**Information Response for MCU Mixed Development
At 49 Macrossan Street, Port Douglas (Planning Act)**

I refer to Council's confirmation notice of 16 October 2017 and the Information Request of 18 October 2017. I am pleased to provide you with the information response for the above described application in accordance with section 13.2(b) of the Development Assessment Rules and Council may now proceed with its assessment of the application.

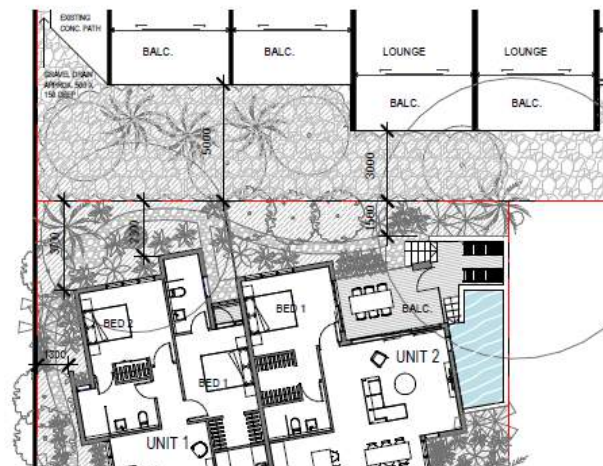
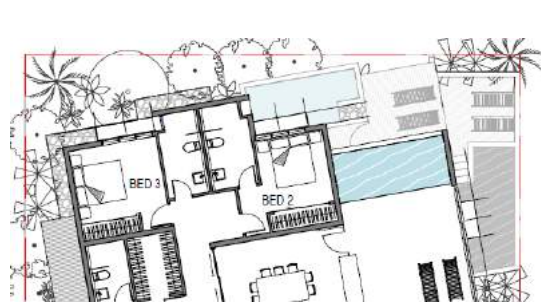
7.3 *Where there is a direct line of sight from a habitable room or a deck on the neighbouring land or a residential unit advise how views will be limited and privacy maintained.*

Clarify the location of habitable rooms on adjoining developments and state how the development "complies" and "will be complied with". Provide details of any screens that are proposed to patios and balconies within the development.

The design of the proposed units has been amended (extracts below for ease of reference):

- There is an overall increase in distance between the building and the rear boundary for landscaping and privacy.
- The ground floor units 1 and 2 are screened from the neighbouring premises by landscaping and fencing.

- Unit 1/3: Bedroom windows are approx. 2.5m from the rear boundary.
Bedroom is at an angle to the rear boundary and does not overlook neighbours.
Bedroom is not directly overlooked from the balcony of the premises to the rear.
The neighbouring premises is 5m from the rear boundary in this location.

- Unit 2/4: Bedroom windows have been moved east on the wall
Bedroom is at an angle to the rear boundary and does not overlook neighbours.
Bedroom is not directly overlooked from the balcony of the premises to the rear.
The neighbouring premises is 5m from the rear boundary in this location.

- Unit 2: The stairs and pool deck have been setback 1.5m from the rear boundary to allow dense landscaping
The patio has been redesigned and is at least 2.3m from the rear boundary at the closest point and 7.3m from balcony on neighbouring premises

- Unit 4: Pool and pool deck of unit 4 have been removed
The patio is approx. 2.3m from the rear boundary at the closest point and 7.3m from balcony on neighbouring premises.

- Unit 5: The building is setback at least 2.3m from the boundary
Bedroom 2 windows have been reduced in width
The pool has been redesigned.
The patio has been redesigned and is at least 2.3m from the rear boundary at the closest point and 7.3m from balcony on neighbouring premises.

Original drawings –

Amended drawings –

Original Unit 5

Amended design Unit 5

1 GROUND FLOOR
1:250

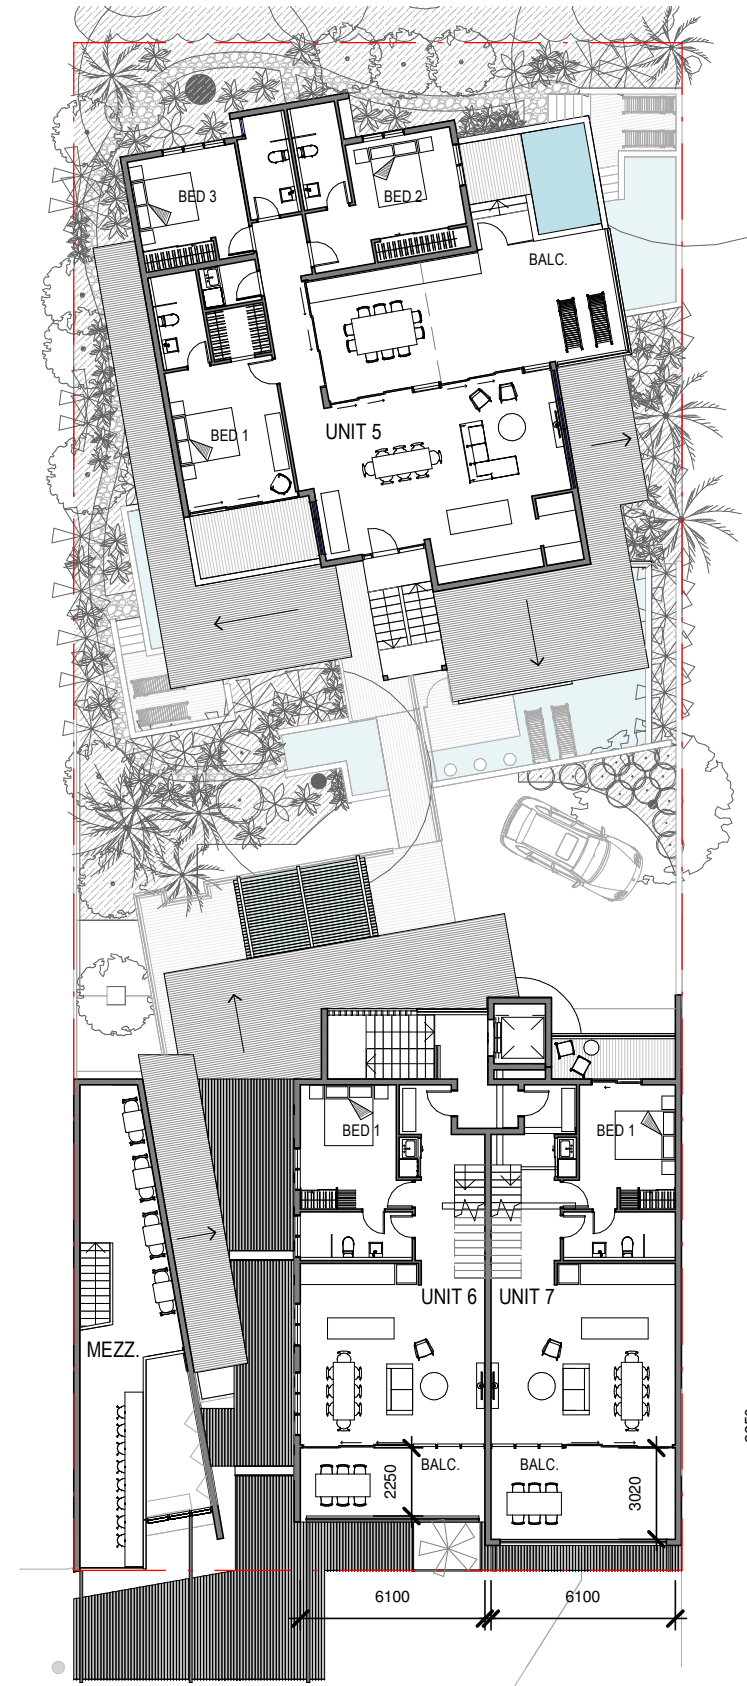
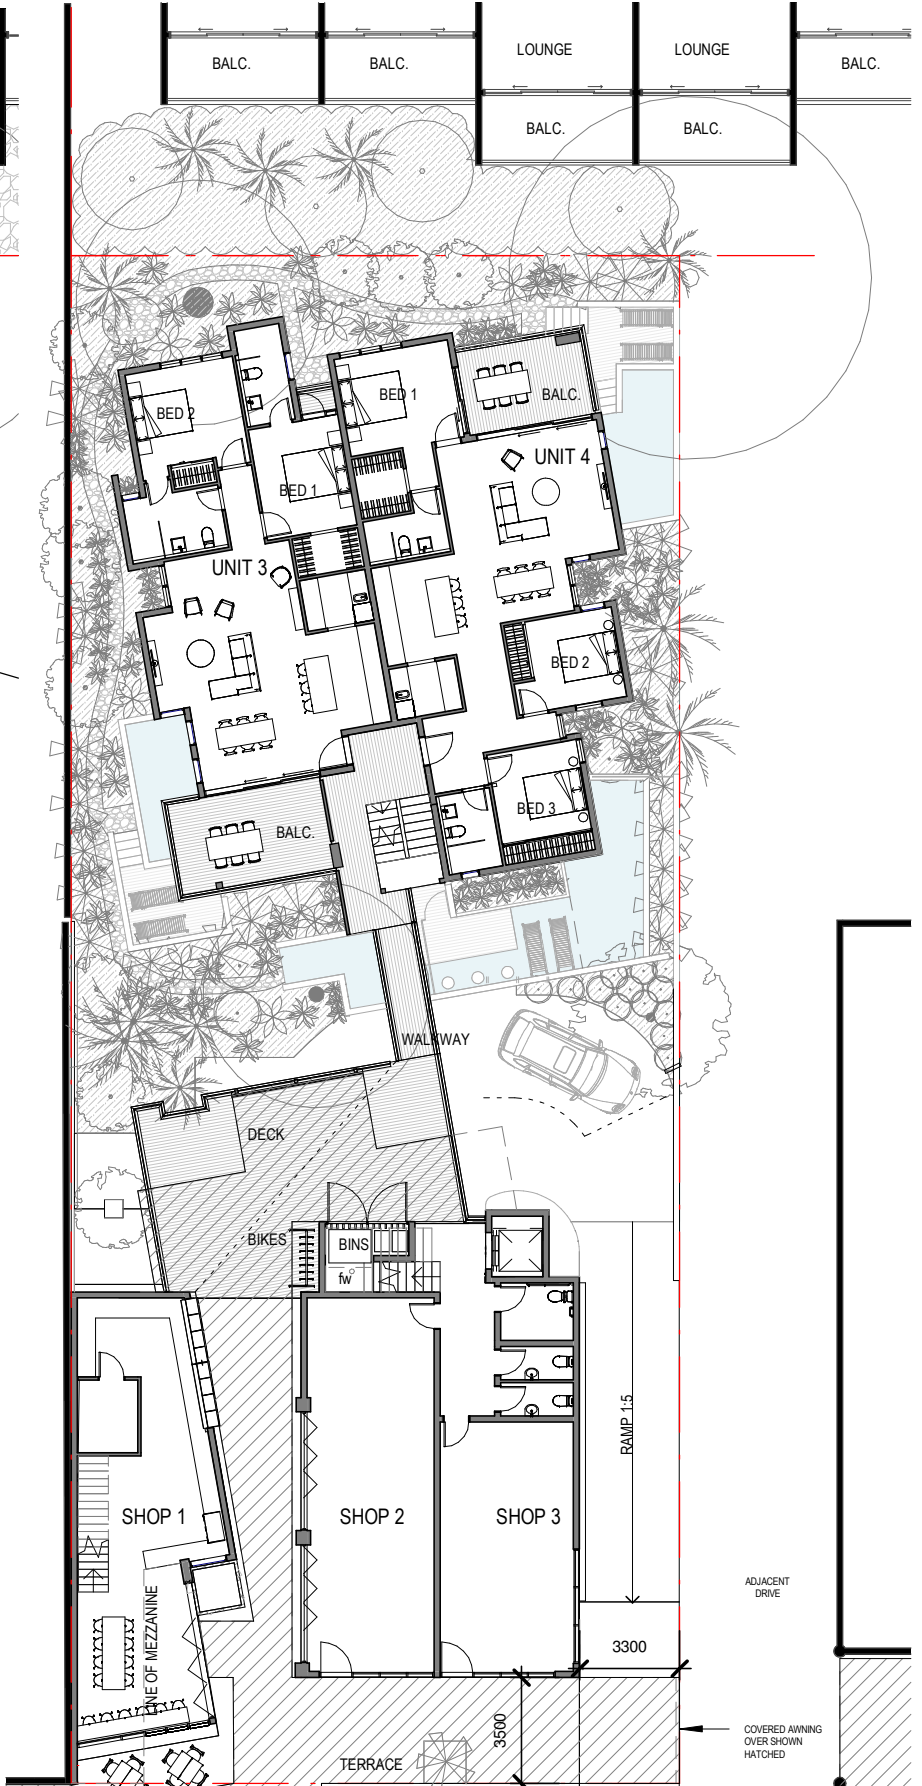
1.1 Clarify by marking on the plans by description and calculated area which building(s) will be used as a Restaurant and/or Shopping Facilities. The use of any terrace or deck area for the Restaurant and/or Shopping Facilities should be identified.

4.1 Please detail the location for bicycle parking on the land

7.1 *Nominate on the site plans and sections, the location and nature of use of the buildings on all adjoining land.*

The **attached** amended floor plans (TPG DA-100H) show bicycle parking on the Deck, near the stairs. The bicycle parking is easily accessed from the terrace between shop 1 and 2. The new Scheme (2016) nominates 1 bicycle space per 100m² of GFA and outdoor dining, which is 3 spaces. The plan shows, and the site allows approx. 7 bicycle spaces.

The attached amended floor plans (TPG DA-100H) show the detail of the adjoining uses:

- East: 3 mixed use residential storey building, built to boundary
- South: Hotel accommodation including balconies and landscaping
- West: driveway of commercial building (Westpac building)

1 SECTION
1 : 200

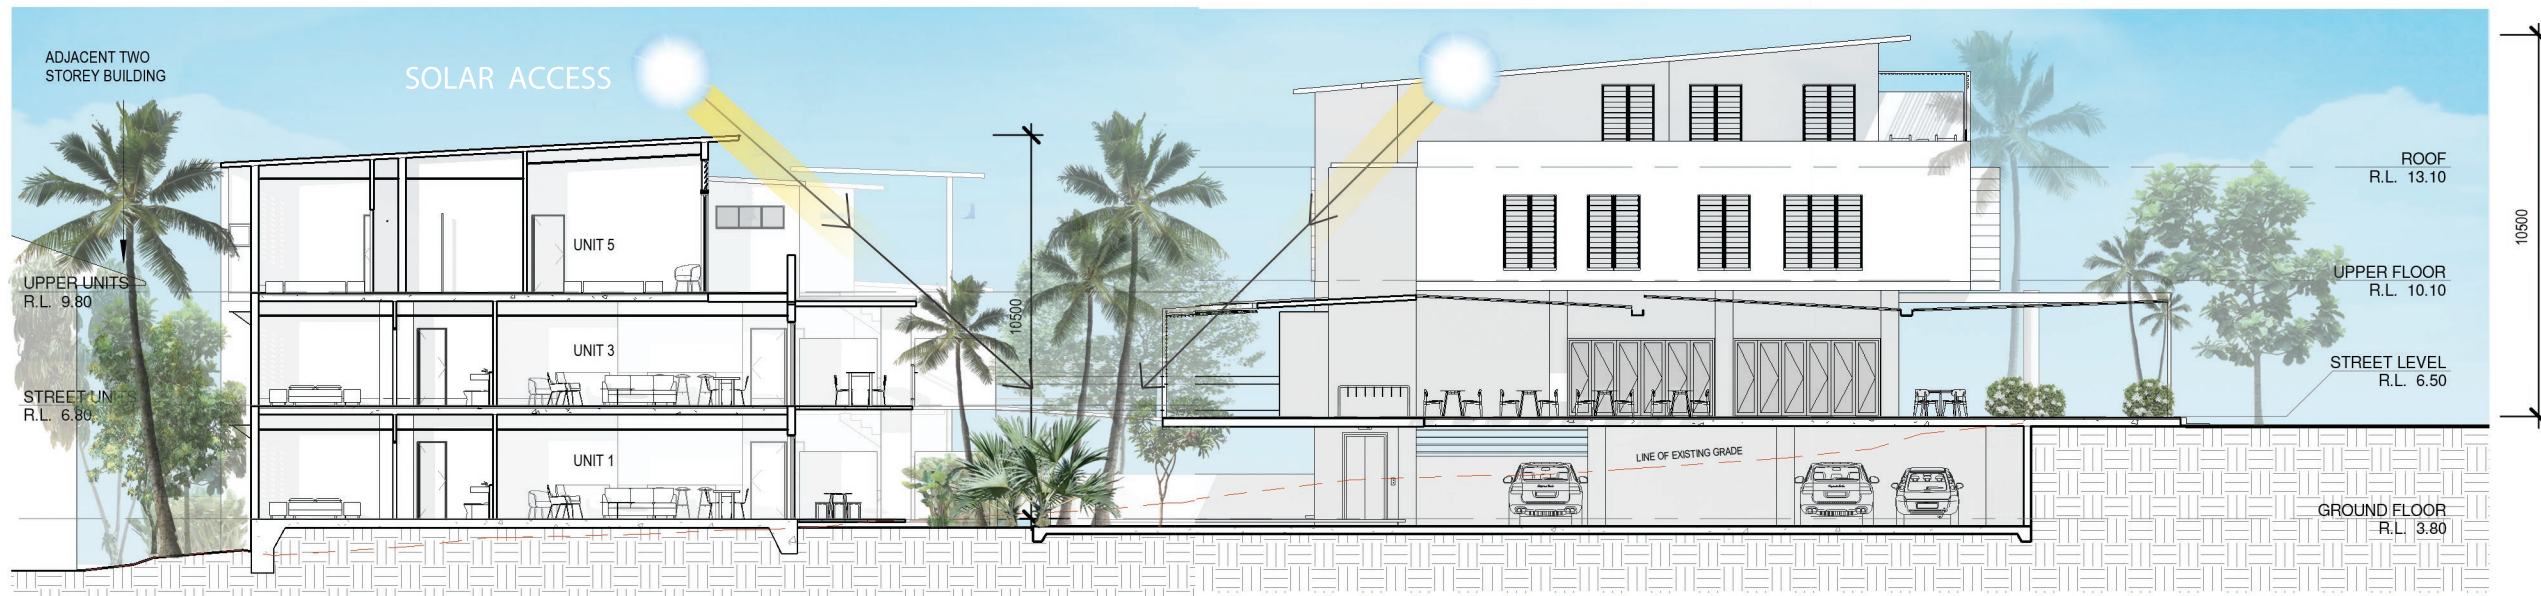
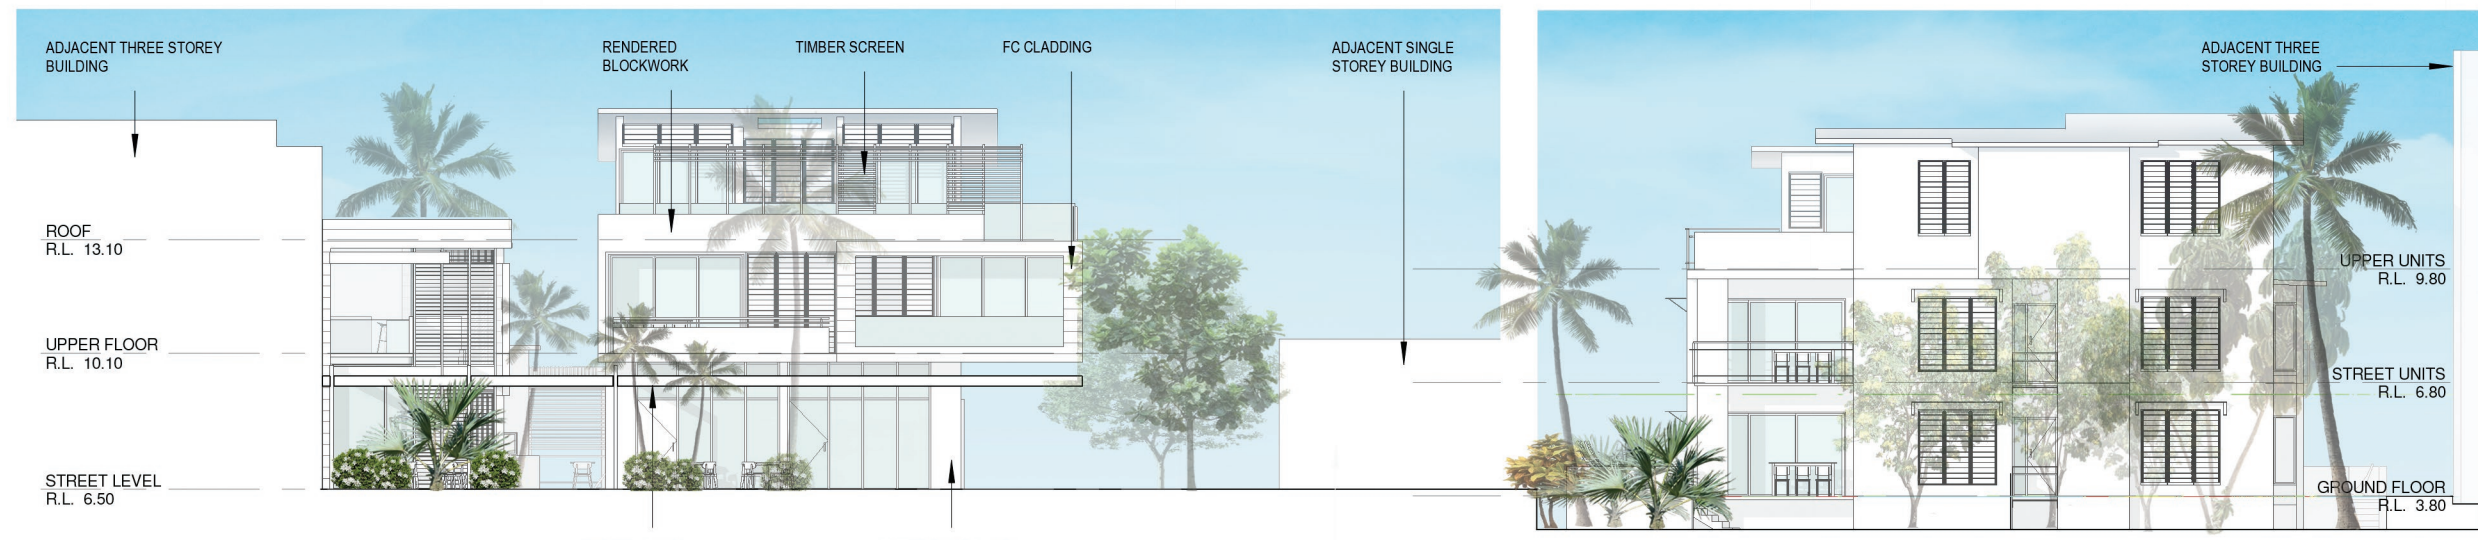
7.2 *Existing sections 1 & 4 are difficult to read. Include the acceptable solution line of setback distance on the section and site plan together with the proposed setback distances.*

8.1 *Nominate the front boundary in Section 1 and the extent of excavation required to construct the basement car park. Where this extent exceeds the land boundary please provide details of resource entitlement or alternatively amend the plans.*

The setbacks of the proposed buildings and the neighbouring buildings are scaled onto the drawings for ease of reading.

The front boundary is shown. The basement is contained within the property boundary.
